# 101 Camley Street, Camden

NMA Design Statement to the London Borough of Camden  
November 2019

This document has been produced in order to update London Borough of Camden on changes to the design of specific elements since the Section 73 NMA Application was submitted in November 2018.

# 03.03 Changes to Lower Ground Level Commercial Entrance and Stair

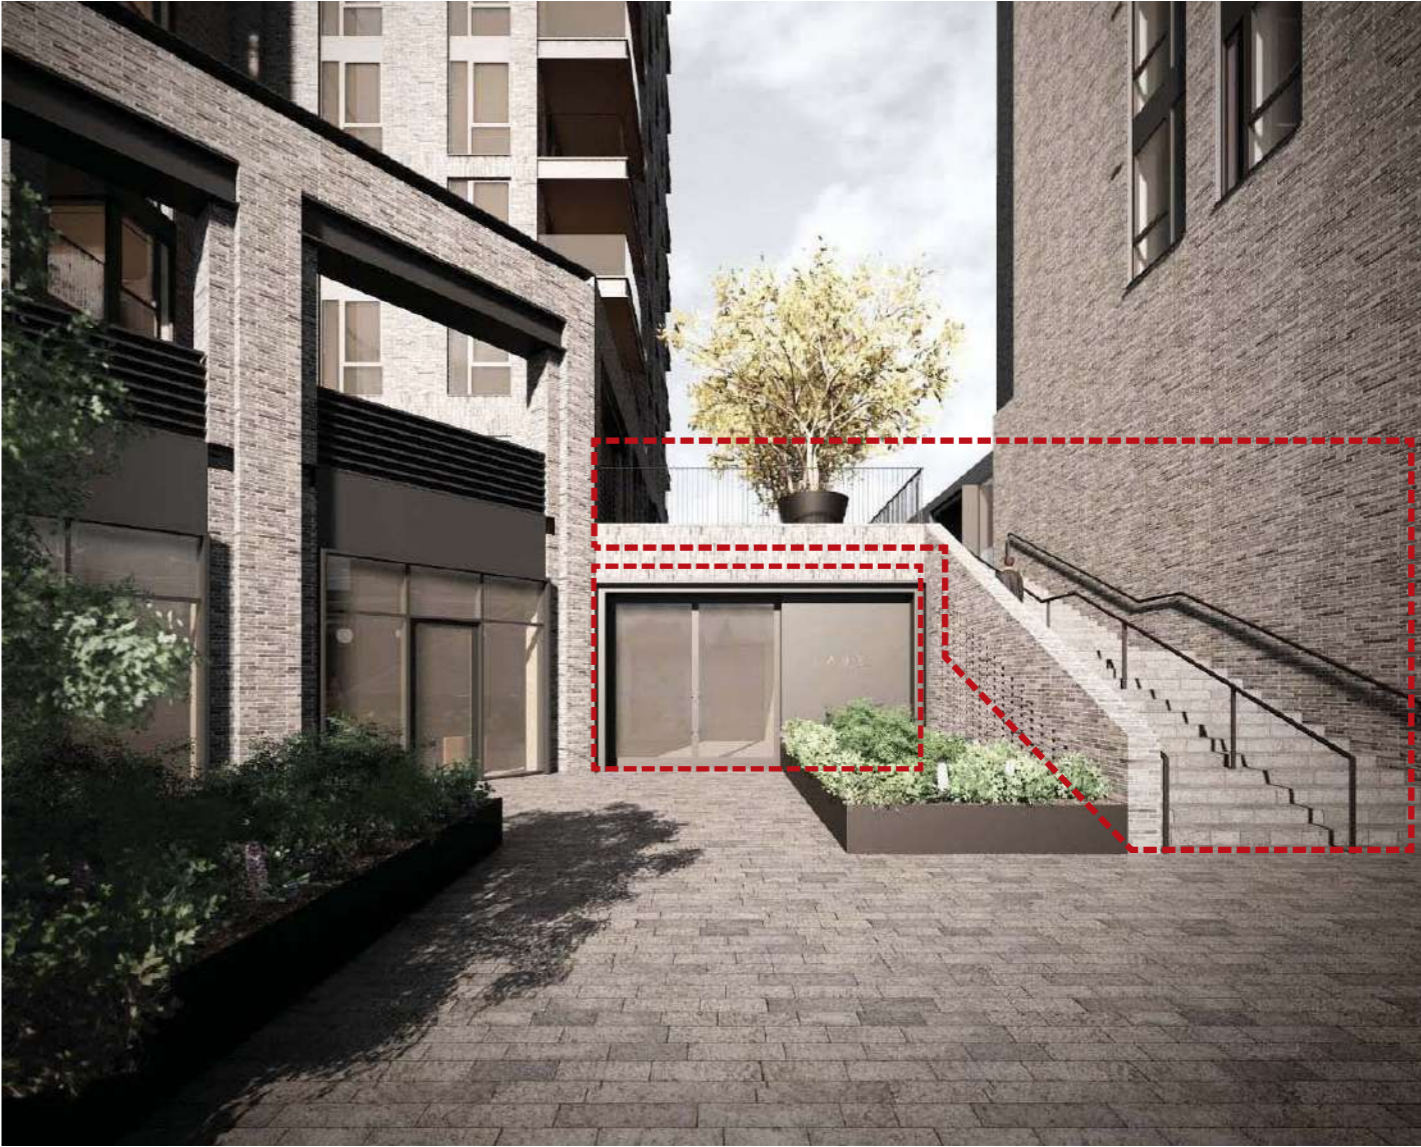
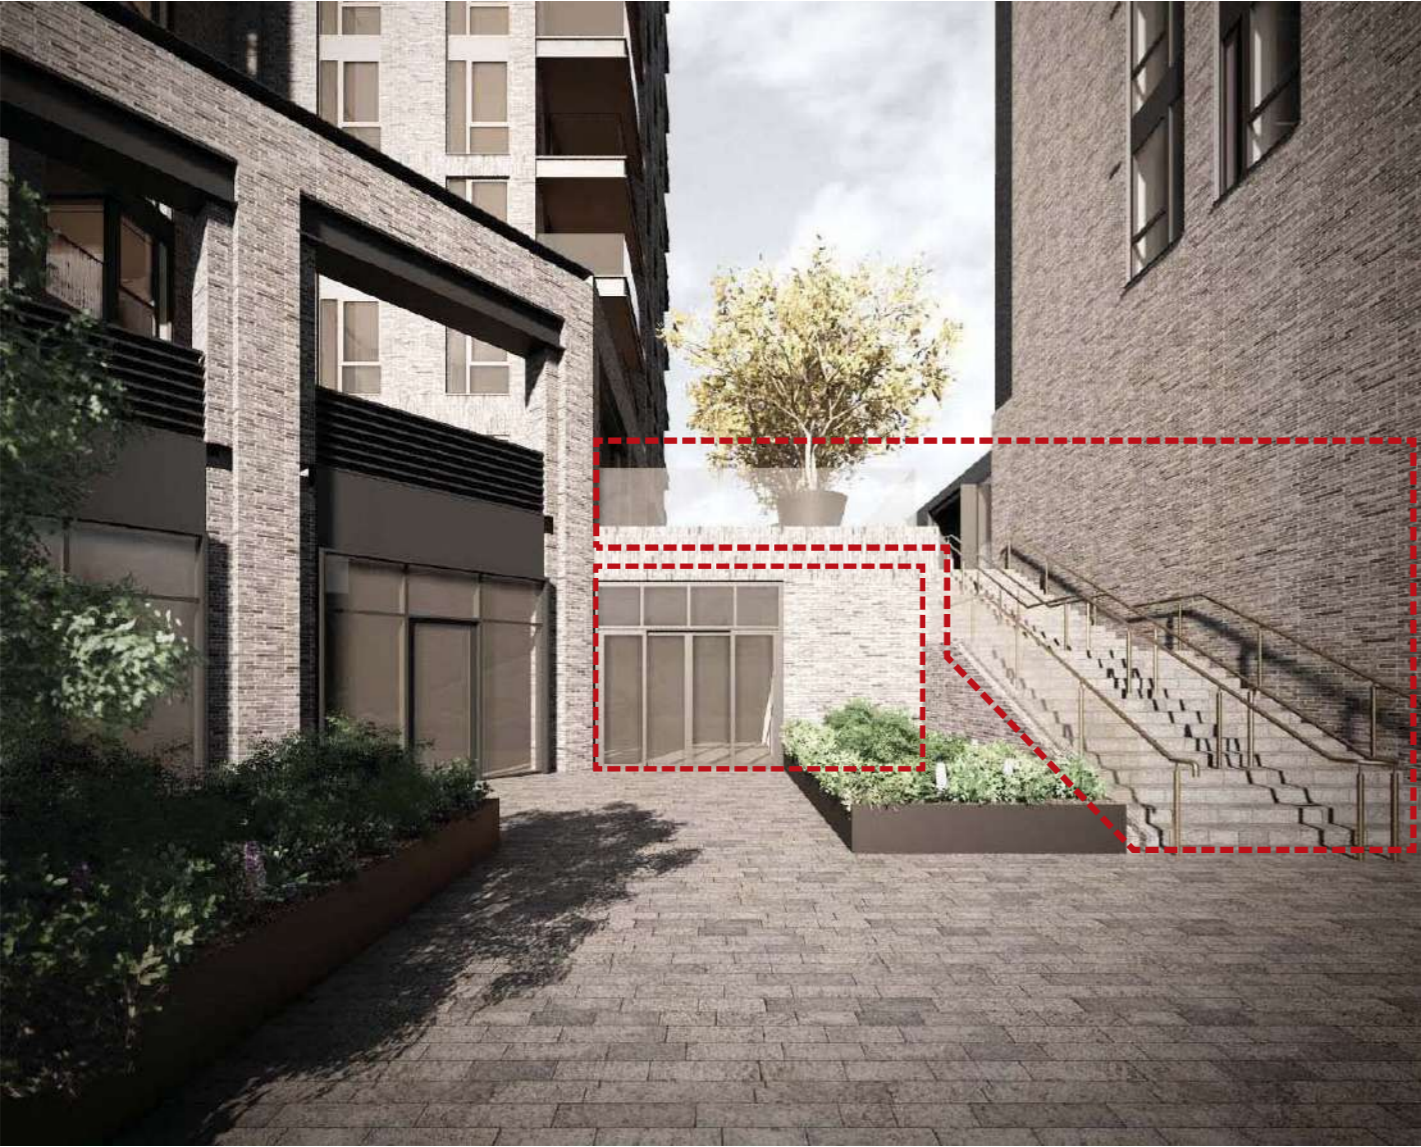
Design change to width of perceived opening and detailing to match all other entrances.

Fixed glass panels and bronze balustrade omitted from original design and replaced with hit and miss powder coated profiles and solid brick to match balustrades and handrails in all other locations. Colour RAL 9005 (Jet Black)

- To improve light levels within the commercial area
- To align with design across the entire scheme.
